Aug. 30th, 2022

MAR/FR200(L) Series Bracket Holes Change Notification

Before (round hole)	After (oval hole)

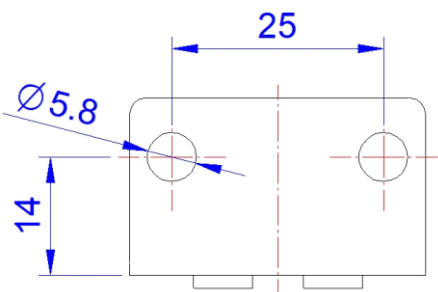
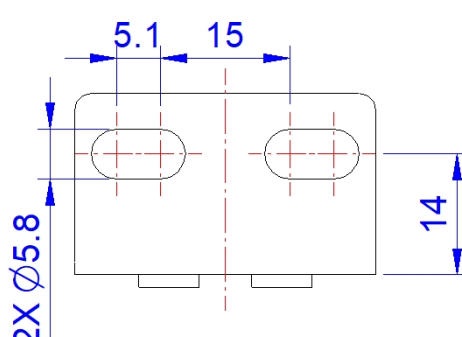
Change design of bracket hole shape to improve ease of installation.
